STATE OF MAINE
DEPARTMENT OF TRANSPORTATION
16 STATE HOUSE STATION
AUGUSTA, MAINE
04333-0016

December 28, 2006
Subject: **Topsham**
Pin No. 14062.11
Amendment No. 2

Work under this contract is generally described as the construction of the MaineDOT TOPSHAM HIGHWAY MAINTENANCE GARAGE

PLUMBING ELEVATIONS
3/8" = 1'- 0"

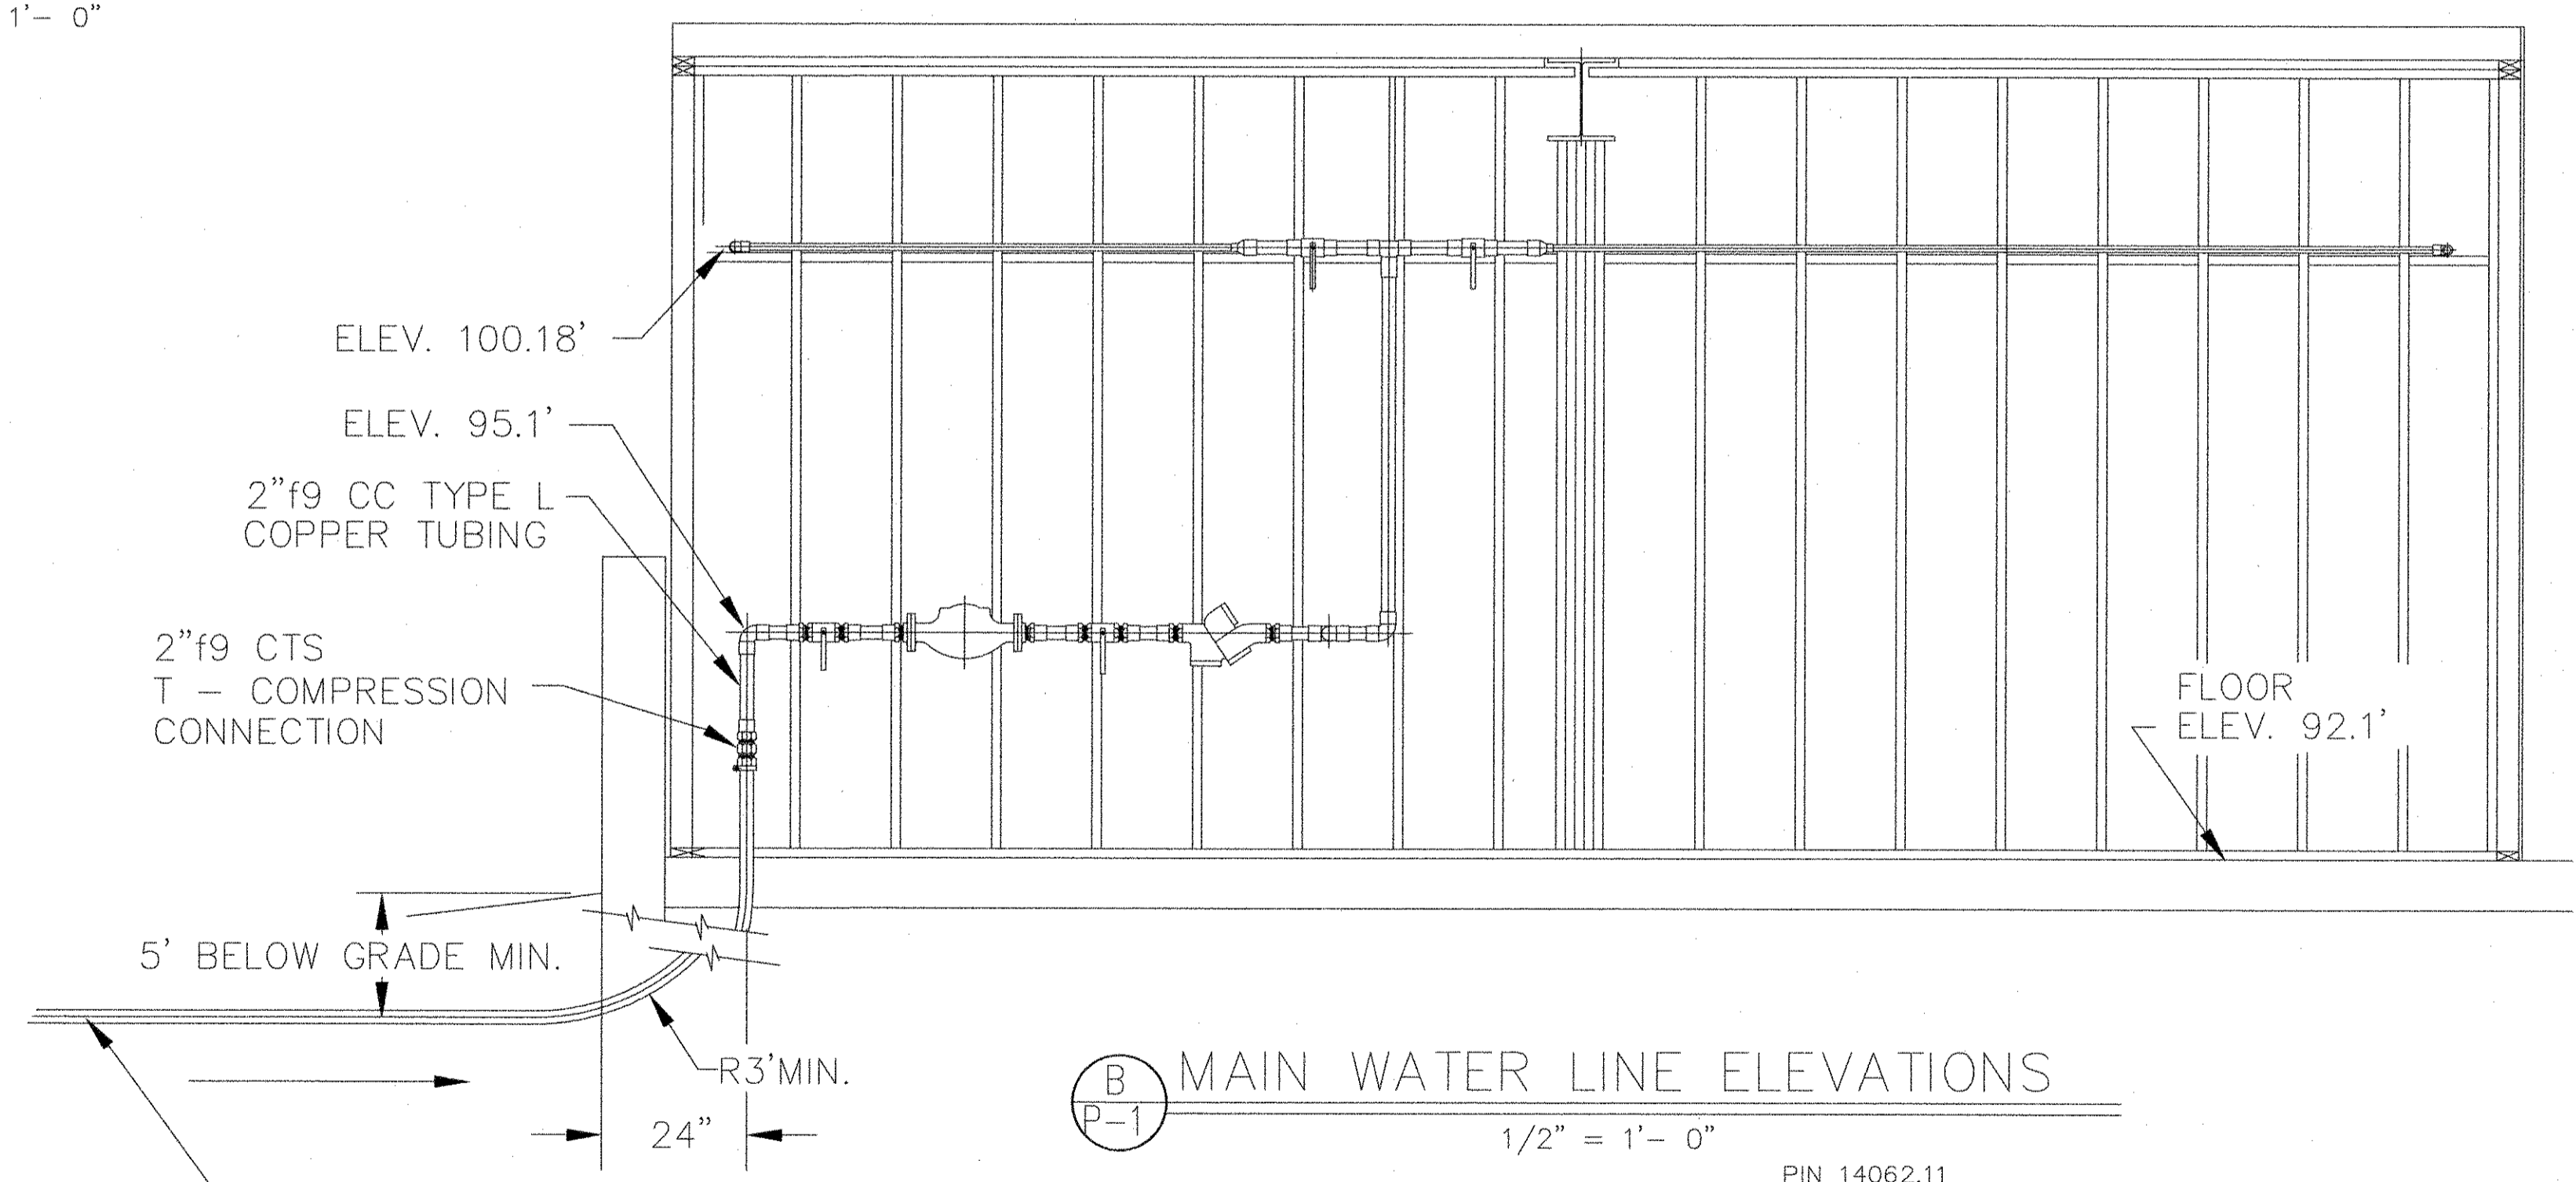
Question: There is no Domestic Water Plan/Sizing/Layout.

Question: Are there any hose bibs required in the garage space/wash bays?

Response: This is shown on the new attached Drawings P-3 and P-4.

Response: There are hose bibs and they are shown on the added attached drawing P-4.

TITLE
MANIFOLD PIPING PLAN

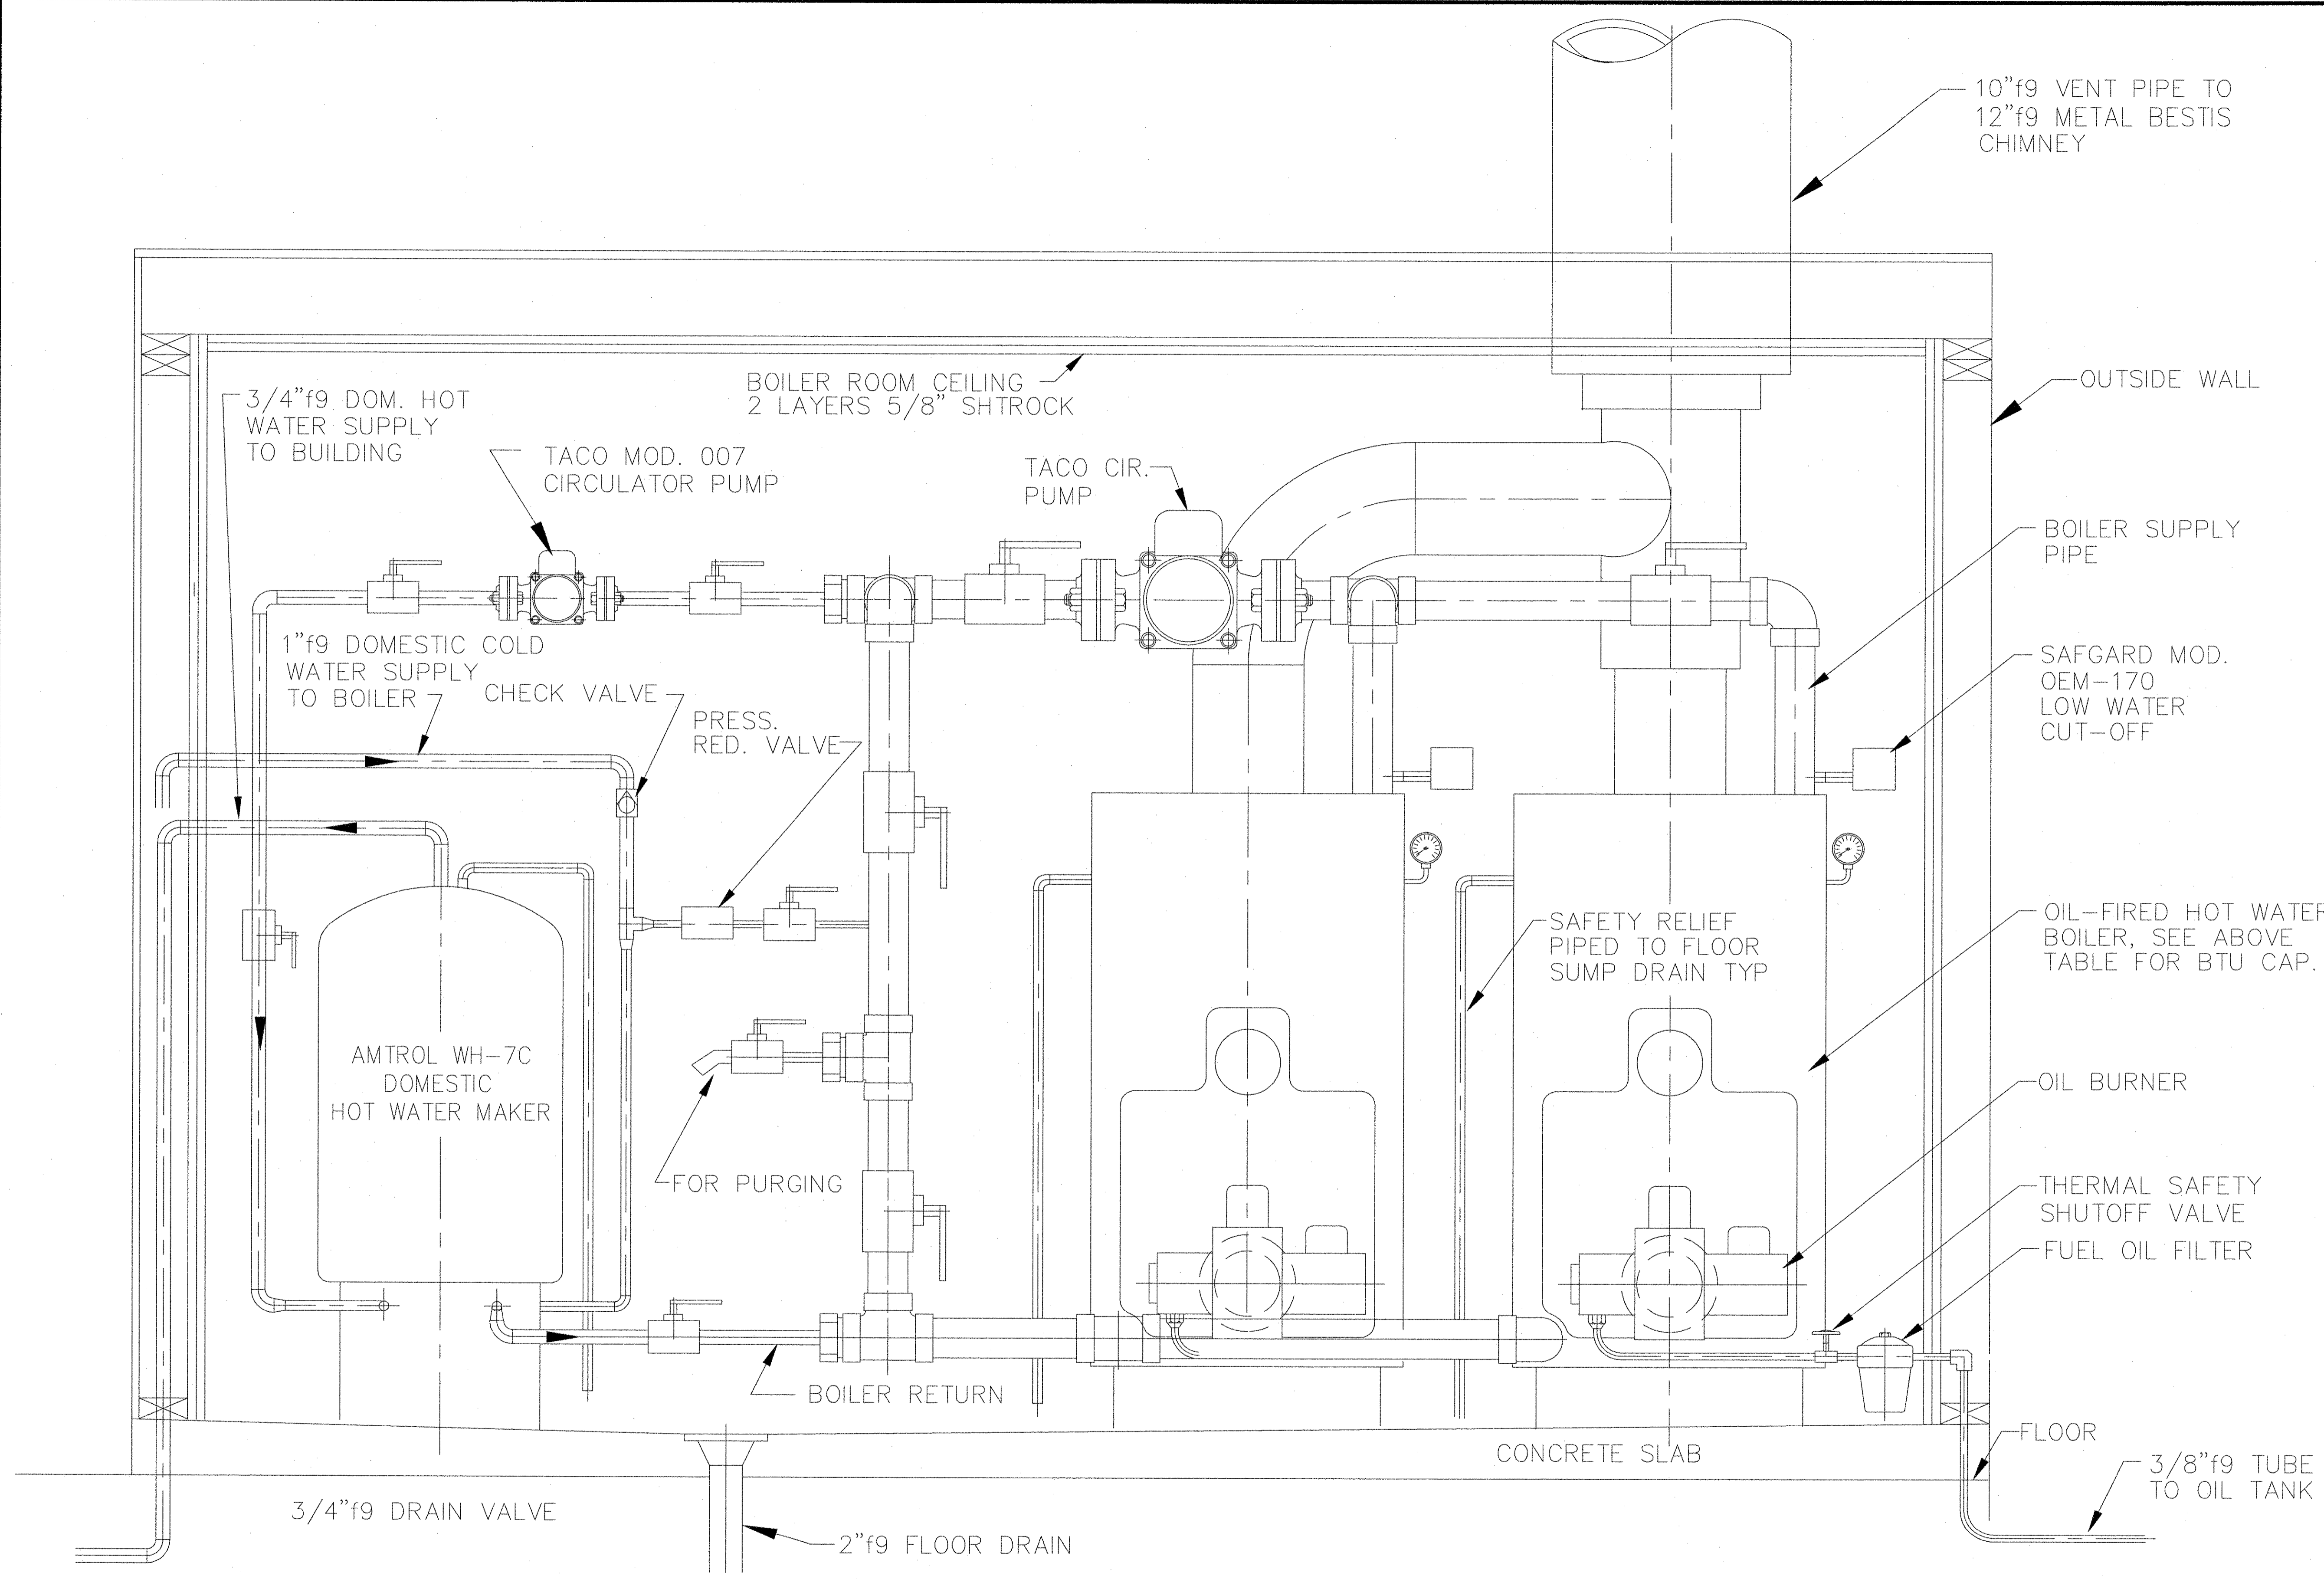
On the Title Sheet named T-1 under "Index of Sheets" ADD the following plansheets: "1st and 2nd Floor Hot & Cold Water Piping Plan", sheet # P-3, "Water Piping Plan", sheet # P-4 and "Manifold Piping Plan", sheet # H-7. Make these changes in pen and ink.

Question: There is no location or specification for the oil tank.

Response: An oil tank and shelter has been added to the attached updated Drawing H-7A.
